The Commission has issued the enclosed Amendment Nos. 87 and 73 to Facility Operating License Nos. NPF-4 and NPF-7 for the North Anna Power Station, Units No. 1 and No. 2 (NA-1&2). The amendments revise the Technical Specifications (TS) in response to your letter dated August 29, 1986. The amendments are effective as of the date of issuance.

NORTH ANNA POWER STATION, UNIT NO. 1

Amendment No. 87  
License No. NPF-4

Amendment No. 73  
License No. NPF-7

Figure 6.2-1 Offsite Organization for Facility Management and Technical Support

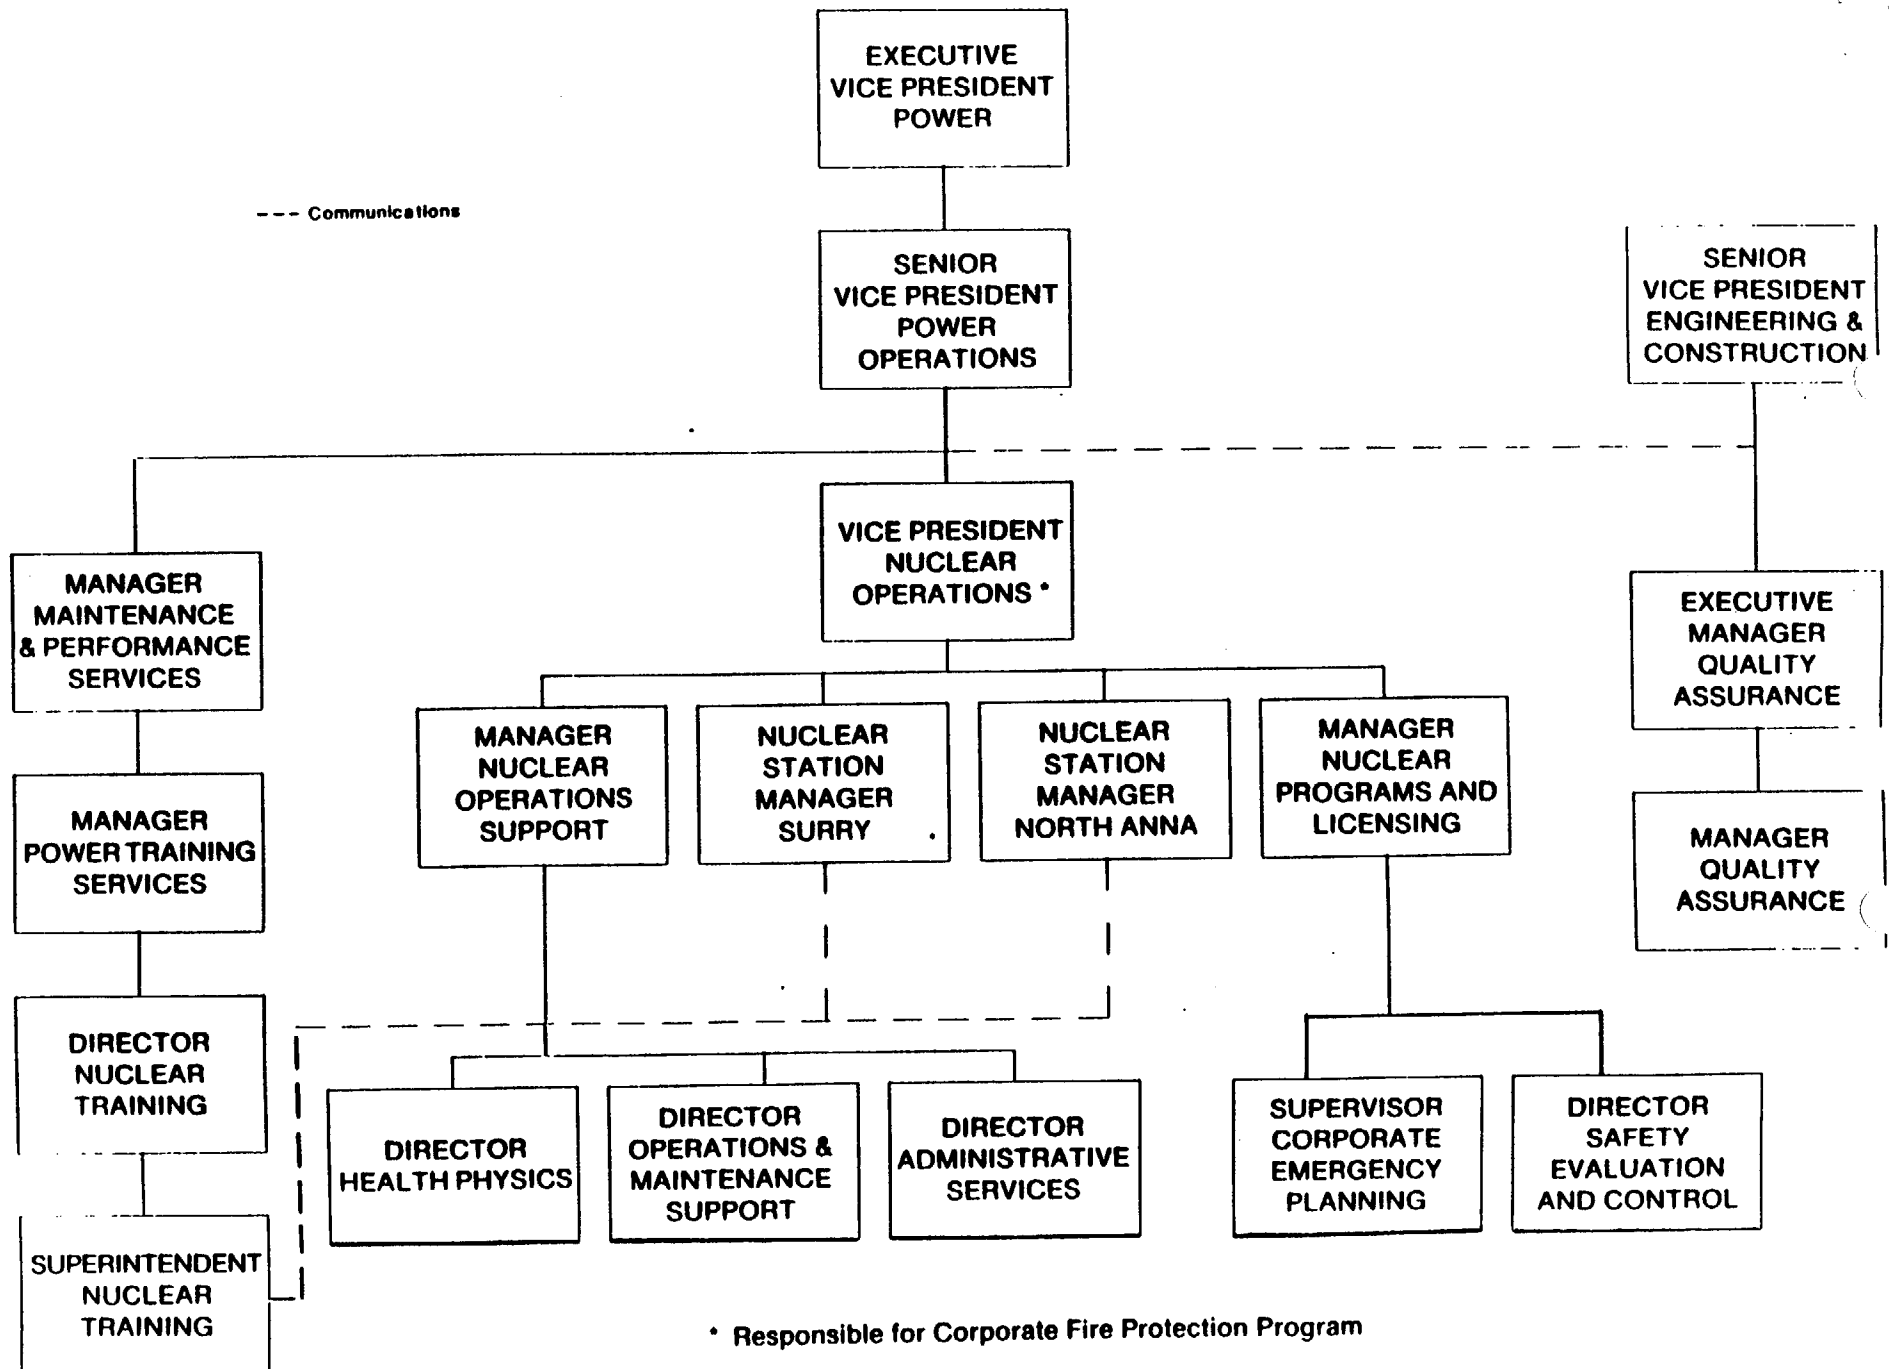
- (1) Reflect a recent company reorganization in which the Quality Assurance organization will now report to the Senior Vice President-Engineering and Construction, instead of the Senior Vice President-Power Operations;
- (2) Change the title of the QC Supervisor reporting to the Manager, QA from "Supervisor - Quality Control - Q.A. Activities" to "Supervisor - Quality,"
- (3) Change the title of "Supervisor Health Physics" to "Superintendent - Health Physics,"
- (4) Change the title of "Director - Emergency Planning" to "Supervisor - Corporate Emergency Planning," and
- (5) Change the facility organization chart to reflect the above recent administrative title changes.
